Case No. PGR2024-00033
U.S. Patent No. 11,732,496

EXHIBIT 1012

U.S. PATENT APPLICATION NO 17/677,210

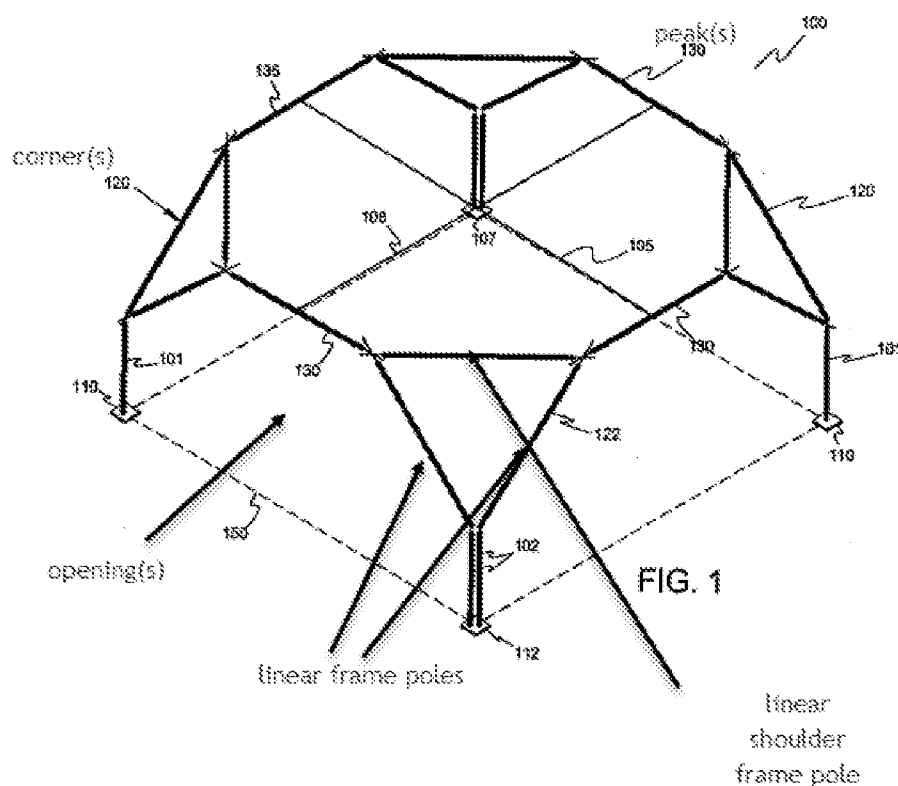
6. Claims 14, 15, and 17-20, as best understood, are rejected under 35 U.S.C. 102(a)(1) as being anticipated by U.S. 2008/0006316 to Jensen.

Note the marked up figure below.

FIG. 19

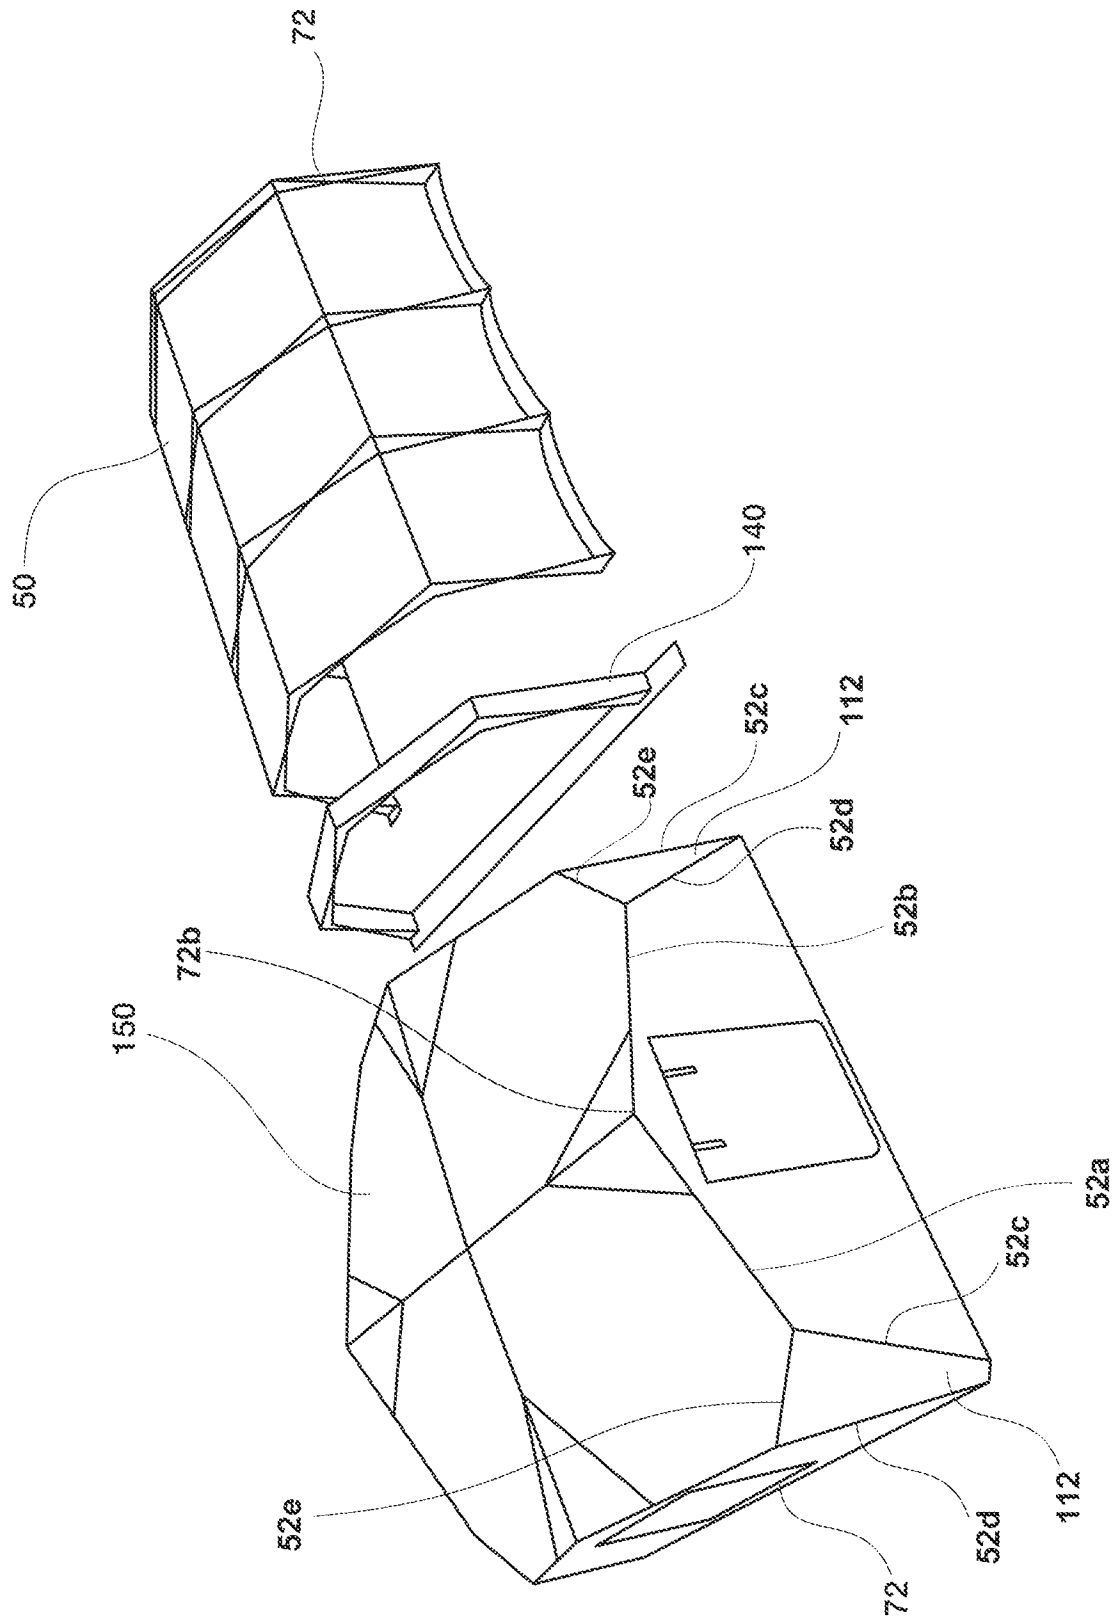
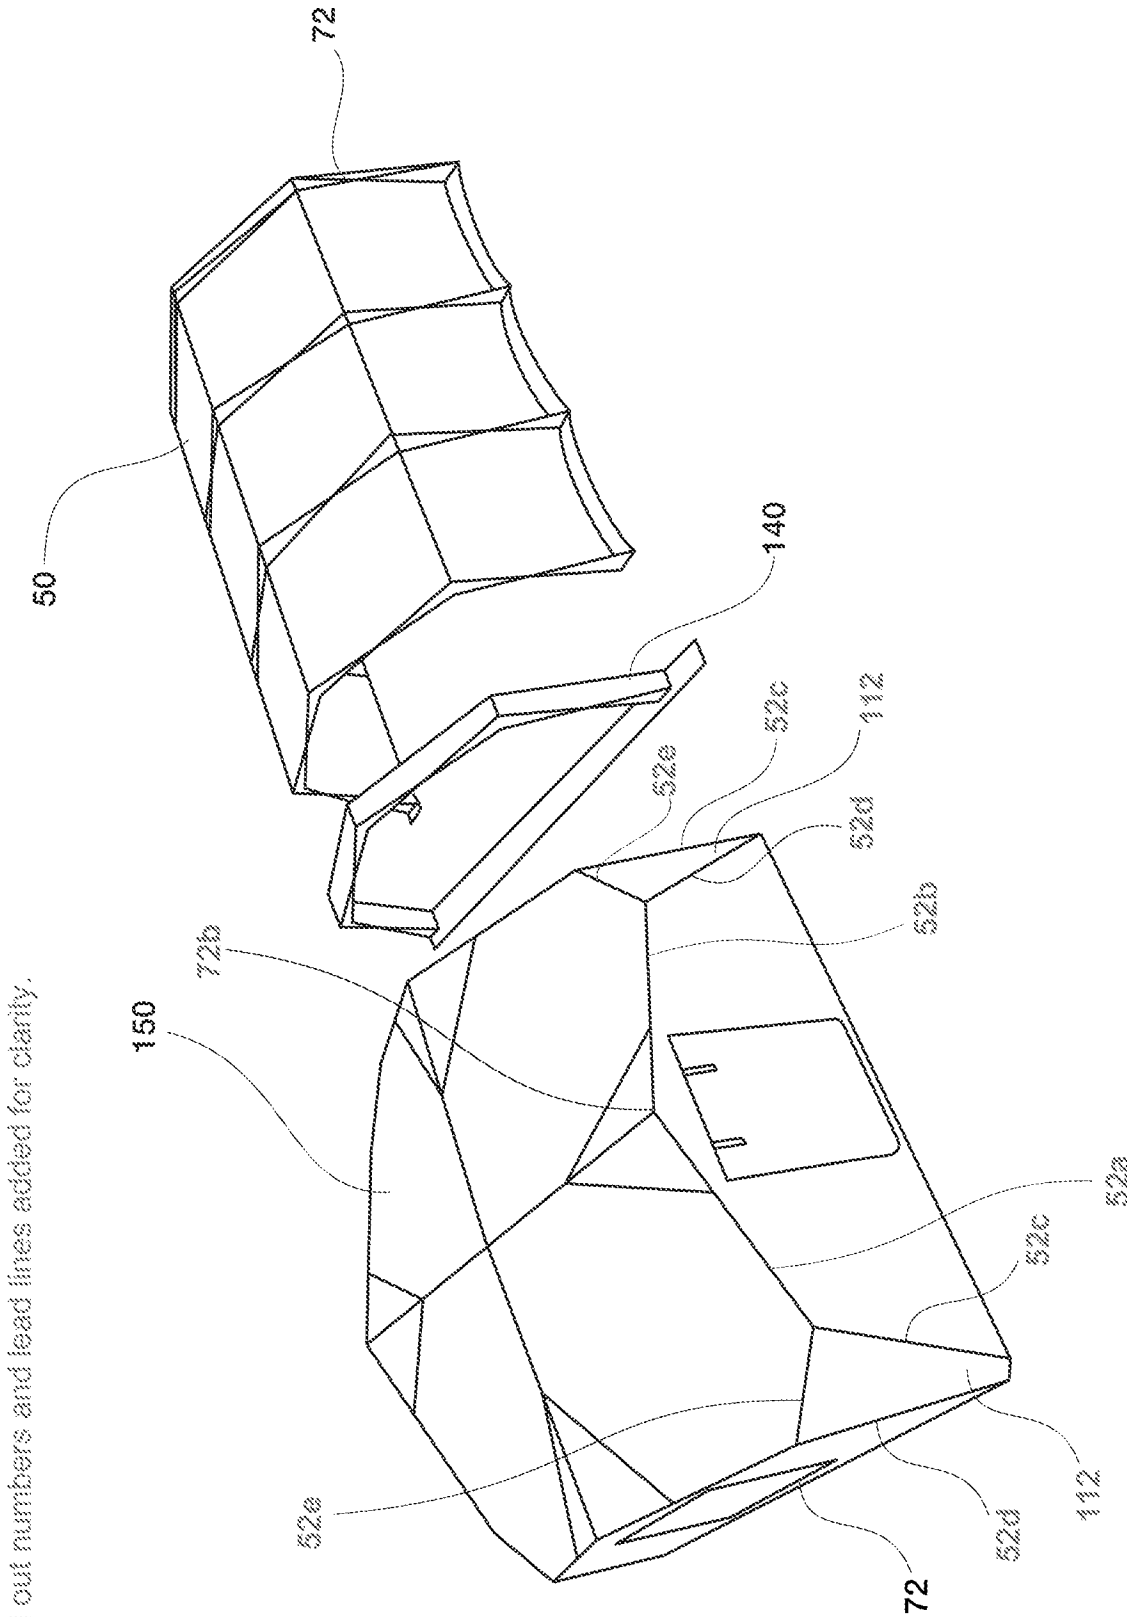
3. The drawings are objected to under 37 CFR 1.83(a). The drawings must show every feature of the invention specified in the claims. Therefore, the triangular frame support between each of the sides at each side interface, the triangular canopy portions and the outer frame perimeter, attached to and extending outwardly from the second shelter exterior frame opening must be shown or the feature(s) canceled from the claim(s). No new matter should be entered.

Call out numbers and lead lines added for clarity.
